Access Compliance Report

Public Rights-of-Way

(Curb Ramps)

Intersection ID: 45785	Main Street: SUGARBUSH_DR	Cross Street: LONG_HILL_DR	Location: S
ADA ID: AC8067E8056B	Ramp Type: PerpDiag	Initial Pass/Fail: Fail	Overall Compliance: No
Severity Score: 12.5			
Codes/Mitigation Info/Possible Solution		Field Measurements/Component Compliance

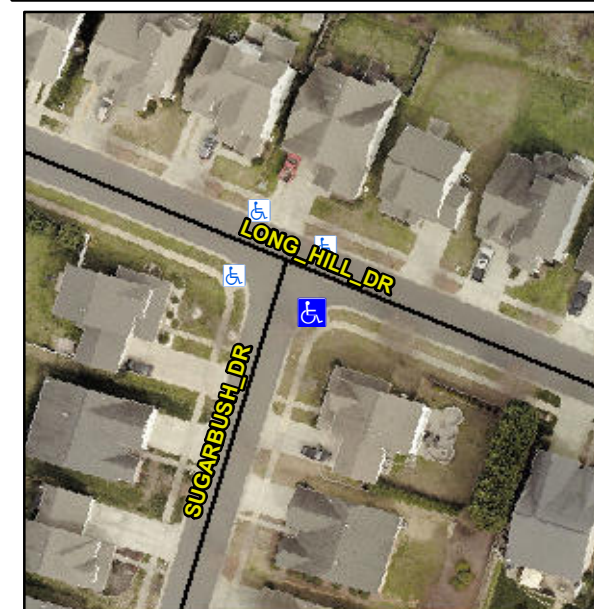
Not Found, R304.5.3

Compliance	Description	Data	Compliance	Description	Data
N/A	Ramp Length (in)	70.0	Yes	Ramp Slope (%)	5.1
Yes	Ramp Width (in)	48.0	No	Ramp XSlope (%)	5.3
N/A	Flare Type LT	N/A	N/A	Flare Type RT	N/A
N/A	Flare Slope LT (%)	N/A	N/A	Flare Slope RT (%)	N/A
N/A	Flare Traversable LT?	N/A	N/A	Flare Traversable RT?	N/A
N/A	Landing Length (in)	N/A	N/A	DWS Provided?	N/A
N/A	Landing Width (in)	N/A	N/A	DWS Contrast?	N/A
N/A	Landing Slope (%)	N/A	N/A	DWS Length (in)	N/A
N/A	Landing X Slope (%)	N/A	N/A	DWS Full Width?	N/A
N/A	Landing Curb? (Y/N)	N/A	N/A	DWS Offset (in)	N/A
N/A	Shared Landing?	N/A			
N/A	Gutter Ponding?	N/A	N/A	Gutter Slope (%)	N/A
N/A	Gutter Lip Ht (in)	N/A	N/A	Gutter X Slope (%)	N/A
N/A	Painted X Walk1?	No	N/A	Painted X Walk2?	No
	X Walk 1 Direction	To NE		X Walk 2 Direction	To NW
N/A	X Walk 1 Width (in)	N/A	N/A	X Walk 2 Width (in)	N/A
	X Walk 1 Slope (%)	3.5		X Walk 2 Slope (%)	3.4
	X Walk 1 X Slope (%)	0.6		X Walk 2 X Slope (%)	4.0

Remove & Replace Curb Ramp With Two New Directional Ramps or Equivalent.
